# A428 Black Cat to Caxton Gibbet Road Improvement Scheme

Planning Inspectorate reference: TR010044

## Joint Written Representations

Document reference: CLA.D1.WR

**Figure 2: Current Proposal - Offline design of B1046 and Potton Road Realignment**

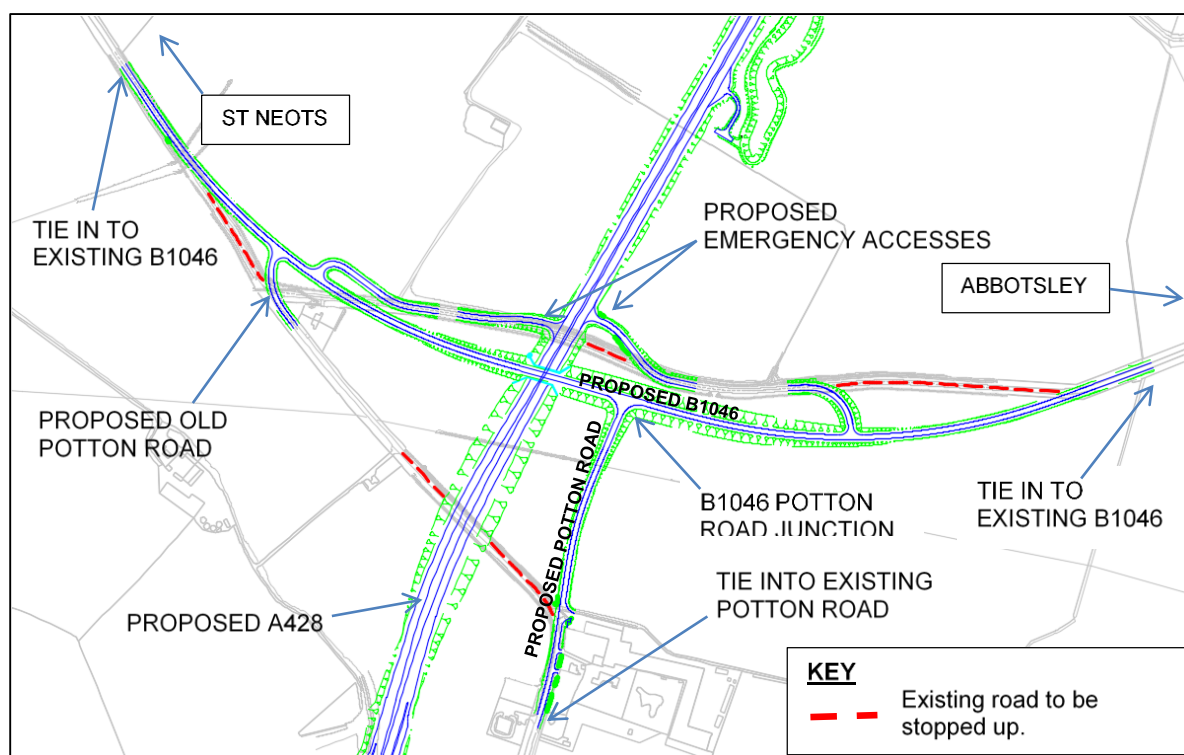
- 4.11.5 The TN states that collision data for B1046 and Potton Road was obtained from crashmap.co.uk website dating from 1st January 2014 to 31st December 2018. There were five collisions recorded in this period, of which none were fatal, 1 serious and 4 slight. These five collisions resulted in 6 casualties and involved 9 vehicles. Most collisions occurred at the junction between the two roads.

- 4.11.6 Contrary to the Applicant’s statement the existing geometry is not “tight” neither is “visibility poor”. The primary safety concern is the existing B1046/Potton Road Simple Priority junction layout; the Applicant’s current proposal for this is a simple priority junction.

- 4.11.7 Accordingly, the principle of the DfS is not accepted by CCC. The Applicant has not provided sufficient evidence to demonstrate that there are exceptional situations that necessitate the DfS; that permitted Relaxations have been considered; and that a compliant design is not realistically achievable.
- 4.12 Location Specific Assessments: Package 3 Toseland Road
- 4.12.1 The Applicant’s Technical Note (TN) dated 19th February 2020 Revision P02 Status S3 Document ID: HE551495-ACM-GEN-A428\_Z\_Z\_ZZ-TN-

Figure 4: Surface transport GHG emissions since 1990<sup>14</sup> and CCC baseline emission projections<sup>14</sup>.

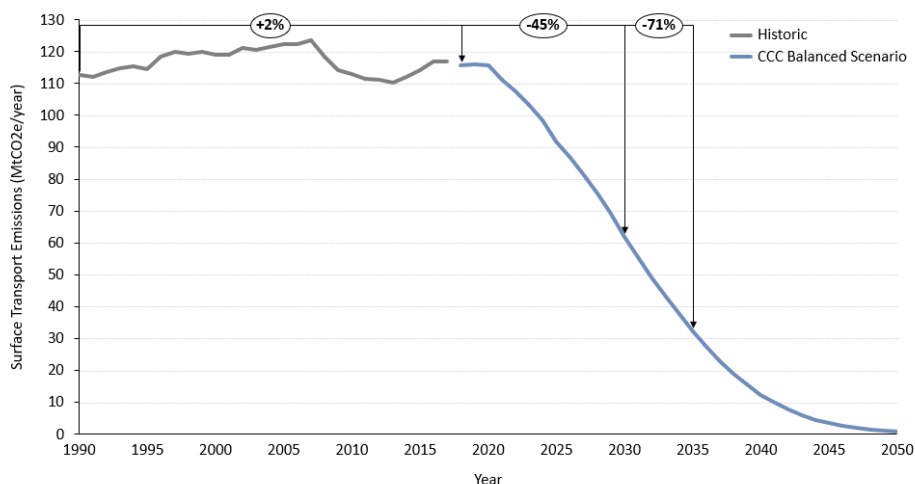
- 15.1 The Councils have concerns about the greenhouse gas emissions associated with the Scheme, and the impact of those emissions on the climate. Other matters of particular concern include climate change mitigation measures, planting to offset emissions, sustainable drainage, carbon emissions and active modes of travel.

Figure 5: CCC car traffic volume change in each net zero scenario<sup>14</sup> compared to the DfT baseline<sup>15</sup>.

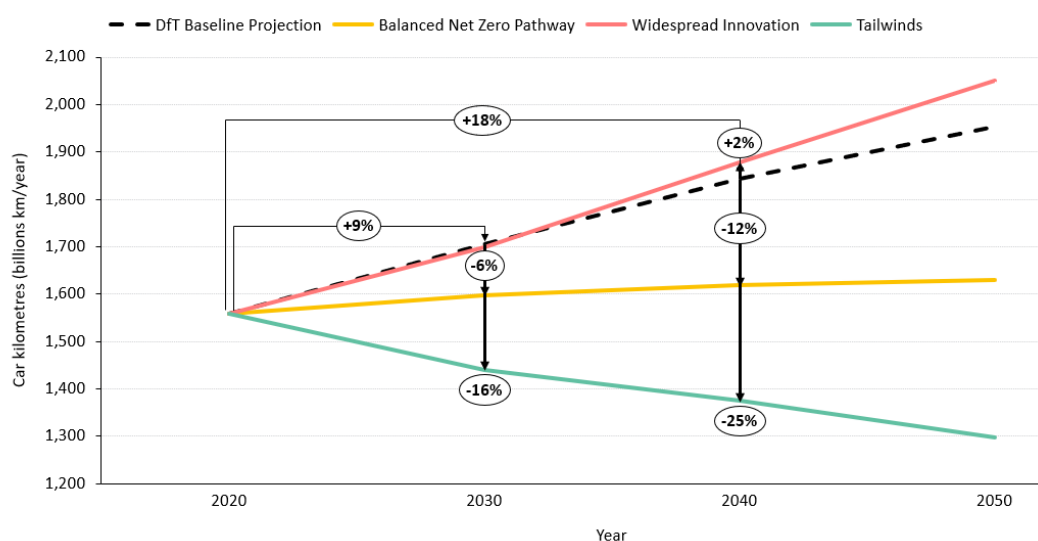
18. The Committee for Climate Change analysis for the 6<sup>th</sup> carbon budget (in figure 2 below) shows meeting this level of emissions change in such a short period will require a significant level of behavioural change. Baseline DfT predictions (black dashed line) for car demand show continued growth (9% by 2030 and 18% by 2040) following past trends driven by increased population and economic activity. The baseline CCC trajectory (yellow line) (used for recommendations and policy setting) shows that these changes are not consistent with meeting net-zero and that the majority of all future growth must be displaced by trip avoidance and modal shift in order to meet existing UK Government climate targets.

- 18.1 Reference is made in the ES to the emissions associated with the operational phase only representing less than 0.117% of the total emissions allowed for in the budget period. While these emissions appear small when presented against a national budget, they still represent an increase in emissions. Most importantly these carbon emissions will add to current emissions. It is important to note that the existential costs associated with these emissions for example extracting emissions from the atmosphere to deliver against our legislative target and costs associated with the wider ongoing societal impacts of climate change are not evaluated. The Committee on Climate Change, in their recent June 2021 progress [report to parliament](#) have noted that “decisions on investment in roads should be contingent on analysis justifying how they contribute to the UK’s pathway to Net Zero. This analysis should demonstrate that the proposals would not lead to increases in overall emissions. Wherever possible, investment in roads should be accompanied by proportionate investment in EV charging infrastructure and in active travel and public transport.” As such the Councils consider that it would be prudent for the
